NAME	PQ-3917 (14P)	MATERIAL	PM-9820	SCALE	1:1	ANGLE	±1°
DRAWING NO.	HX 3906	PIN MATERIAL	CP WIRE	UNIT	m/m	REV.	00
		TOLERANCE OF PIN DIA ±0.05 PIN TENSION LOAD 1.5 kg MIN					
东莞市华欣塑胶制品有限公司 DONGGUAN HUAXIN PLASTIC MANUFACTURING PRODUCTS CO., LTD. TEL: 0769-86388088 86388188 86388288 FAX: 0769-86388111 http://www.hxbobbin.com E-Mail: hxbobbin@vip.163.com		TOLERANCE: 0<L<4: ±0.1 4<L<16: ±0.2 16<L<63: ±0.3		UL REC. : 94V0			
DRAWN & DRAFTED BY		LIN HUA JING		CHECKED & APPROVED BY		DATE: OCT 18 2014

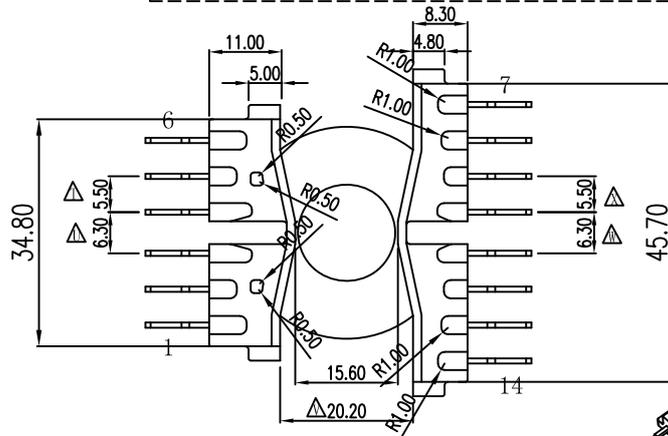
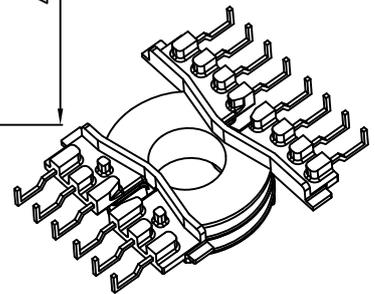
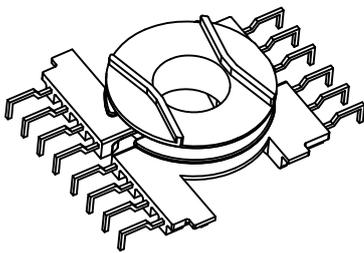
由於排距尺寸焊錫後會變大，現要求插PIN以57.75-57.95之間為標準生產！
